Philips Medical Systems

April 10, 1985
0220-85

REFERENCE: LICENSE NUMBER 06-10081-03
DOCKET NUMBER 030-17244
CONTROL NUMBER 18340

Questions re: their letter of 4/10/85

DOSE RATE VS DISTANCE
FOR MODEL NO. 64-764
GAMMA SURVEY INSTRUMENT CALIBRATOR

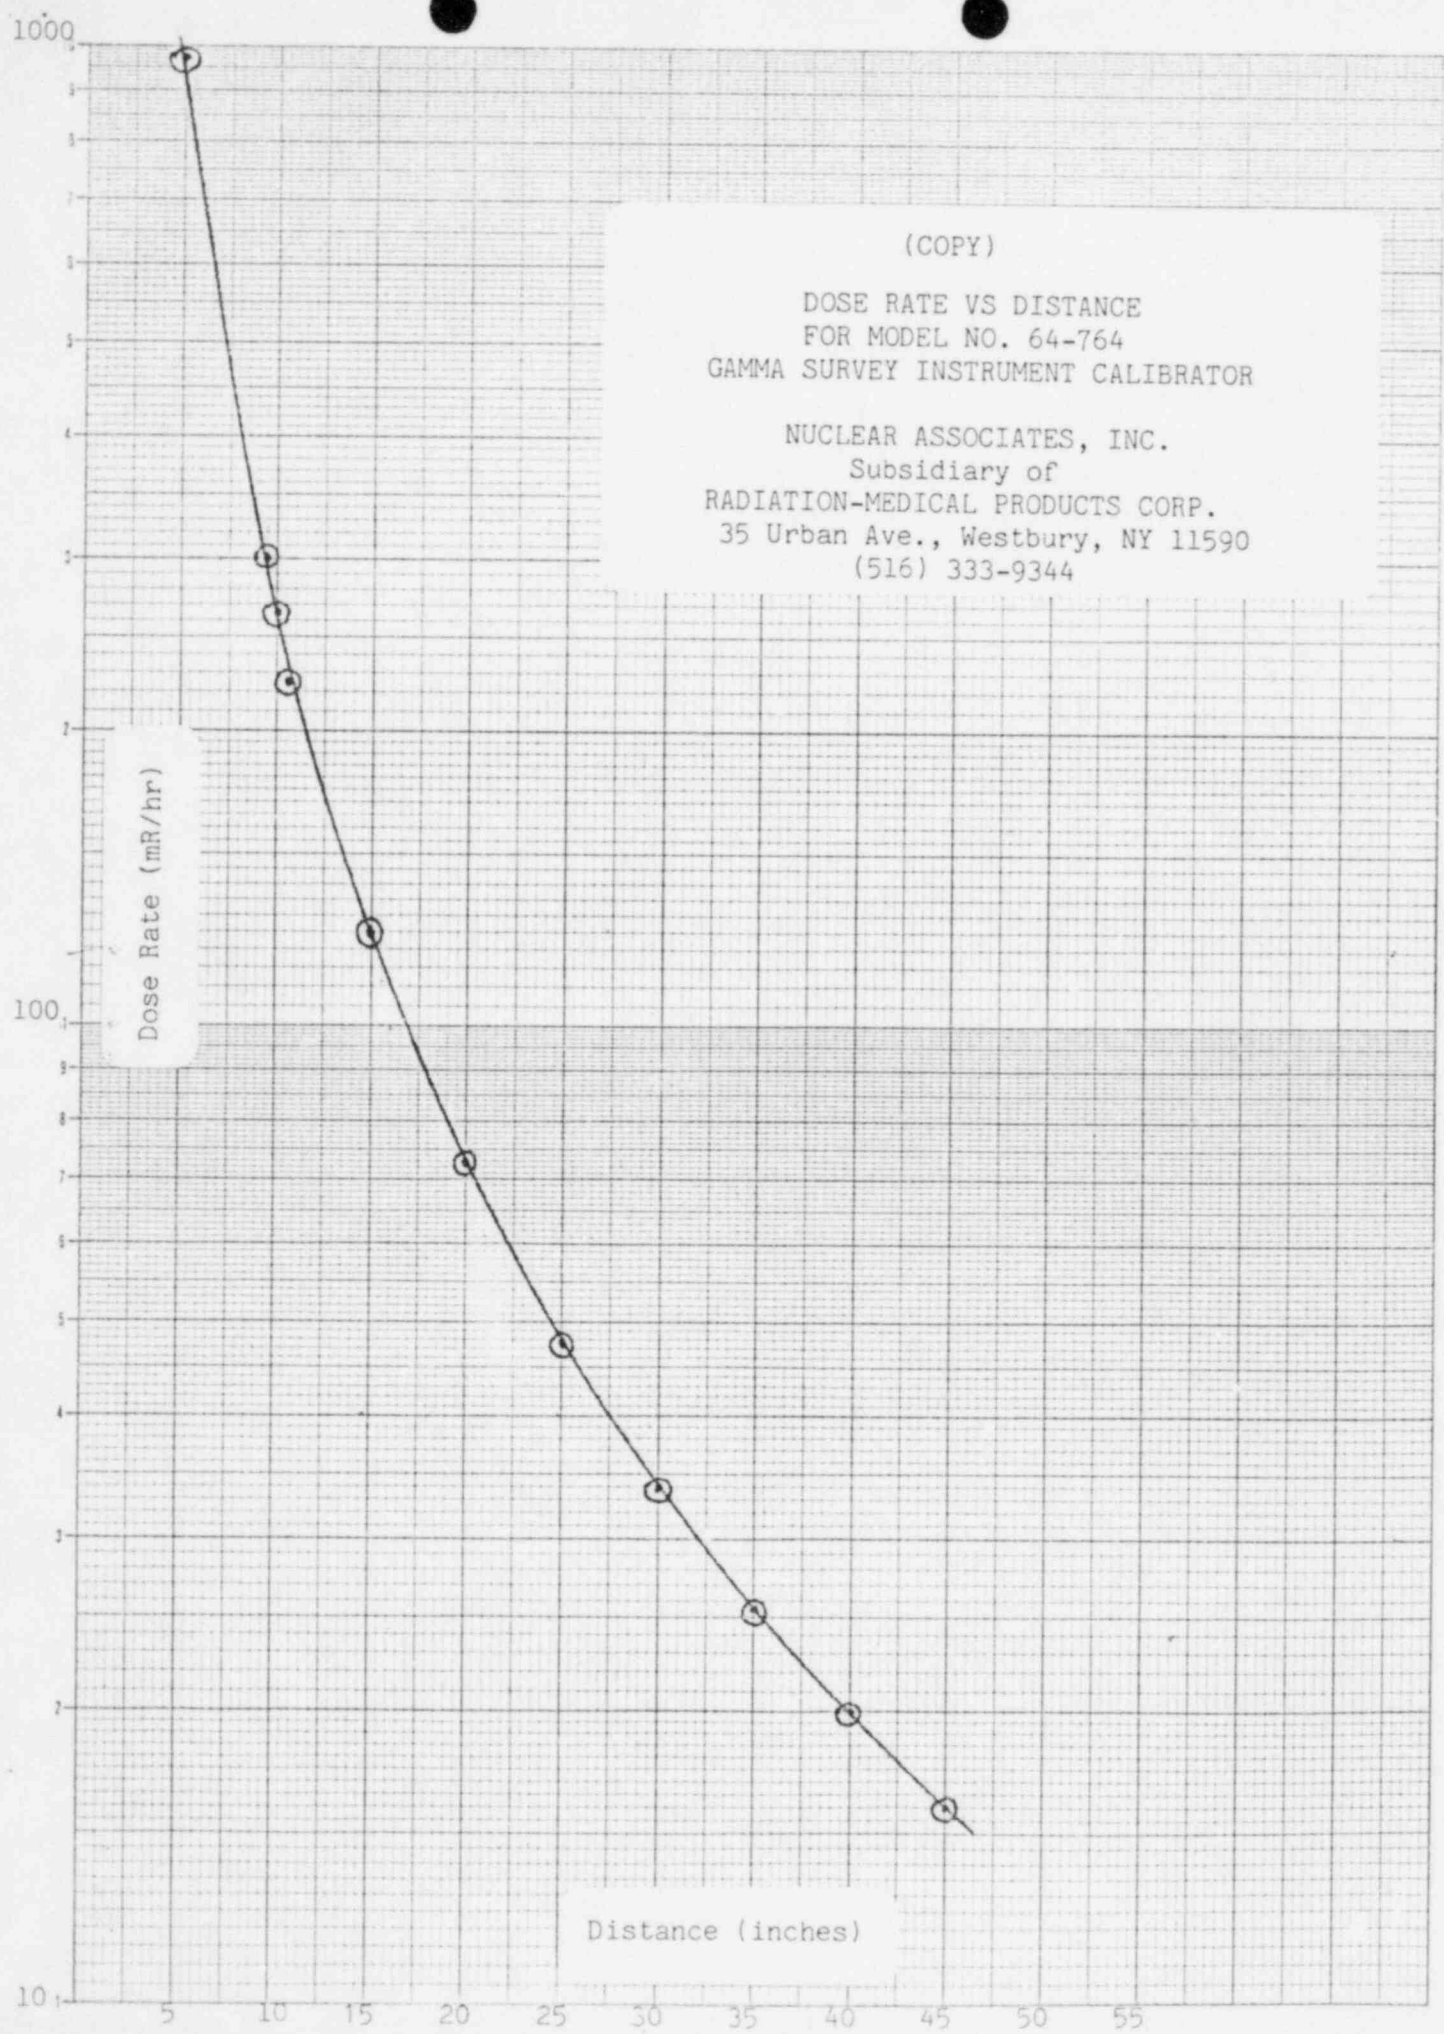
Supplied curve used because curve does not follow inverse square. Radiation levels checked with MDH Model 1015 calibrated by manufacturer. Check \bar{c} 1015 used in lieu of decay correction. Curve extrapolated to low doses. No attempt ~~Records~~ made to determine why inverse square law not ~~so~~ followed, nor to calculate decay of source, nor to calculate dose rate from ~~the~~ gamma factor.

4. (a) Dose rates are not calculated per se. The value of radiation rate output is determined according to the enclosed curve as provided by vendor of the radiation source. (see attached copy)

The measuring points are established by changing the distances to the source according to the emission rate/distance curve.
(see attached)

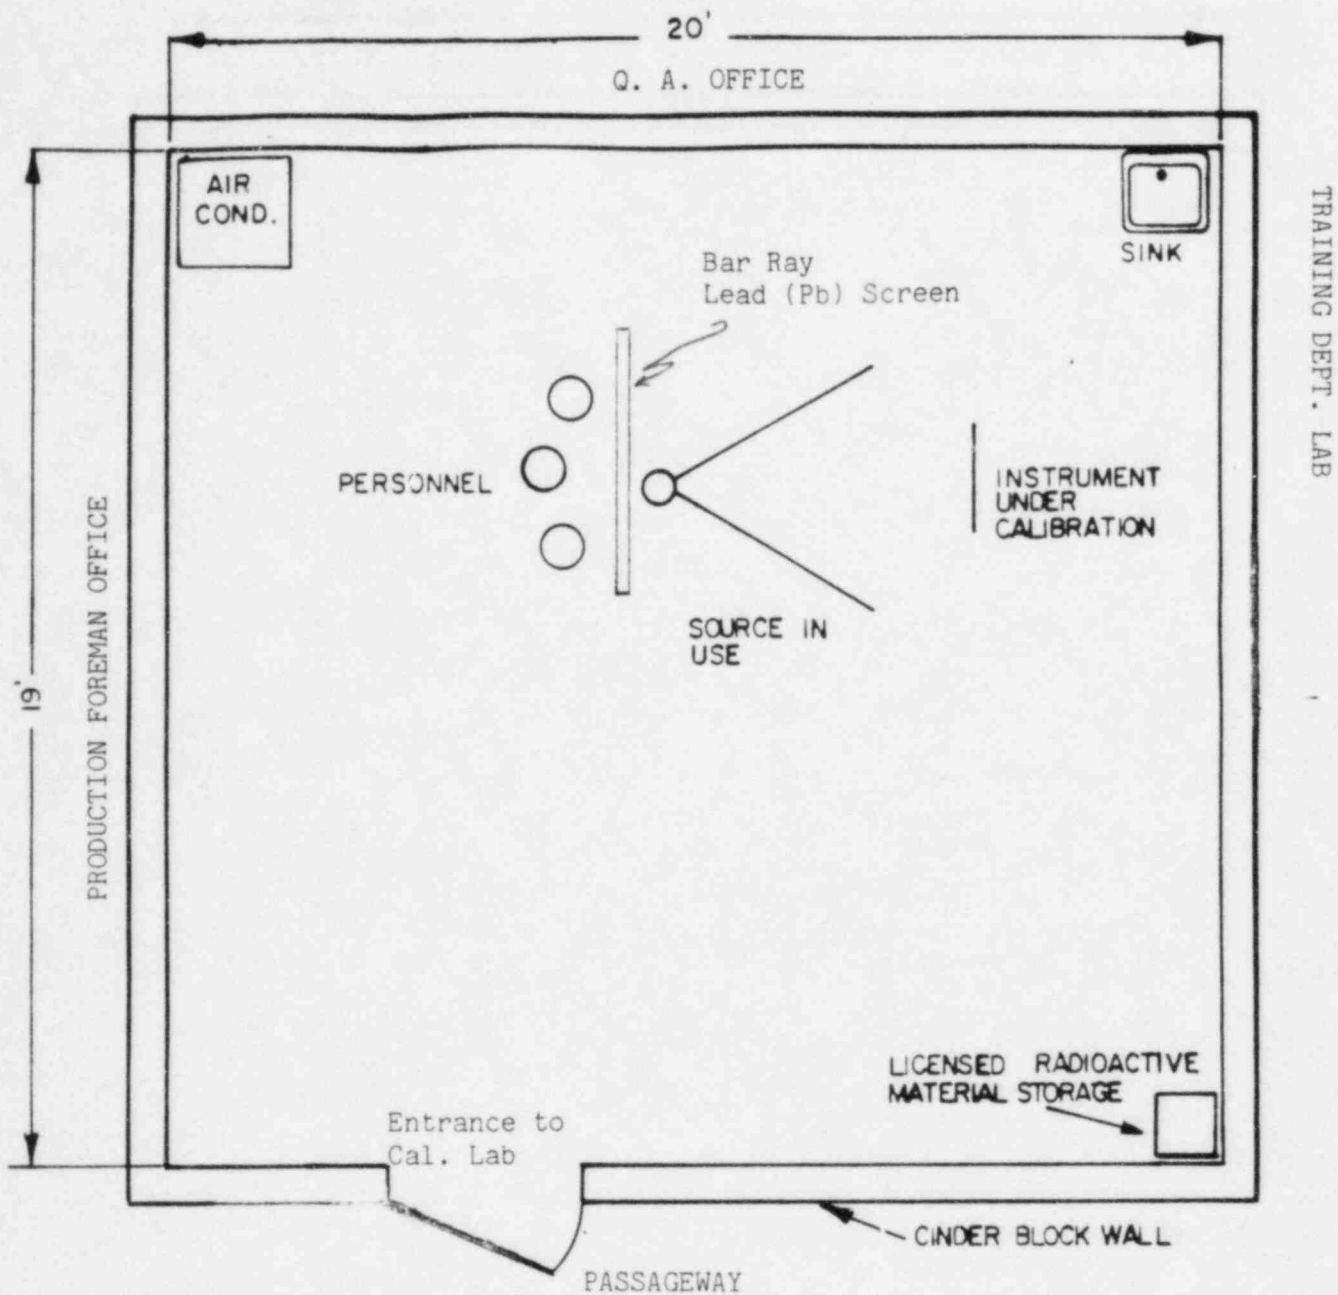
Survey of radiation levels in unrestricted areas O.K.

(d) and (e) Diagrams are submitted as requested. No radiation above background detected at the points indicated.
